IMPORTANT SAFETY RECALL NOTICE

MORryde U-Bolt Torque

MORryde has detected that Ford E-450 units that had wheelbase modification during the dates of March 6th, 2018 through April 18th, 2018, have unverified u-bolt torque and are affected by this recall. The OEM u-bolts were replaced by MORryde as part of the wheelbase modification process. This wheelbase modification service has been sold to numerous RV and bus companies.

EXHIBIT B

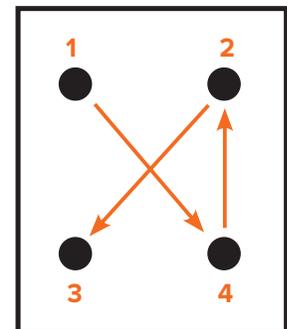
3. Using Exhibit B below as a guide, tighten u-bolt 1 until the torque wrench has reached the set torque 170 ft-lb. After this is complete, continue tightening the rest of the u-bolts following the diagonal pattern depicted in Exhibit B in order 1, 4, 2, 3.
4. Once all four u-bolts on one side of the vehicle have been tightened to the required torque to 170 ft-lb, repeat step three on the other side of the vehicle.
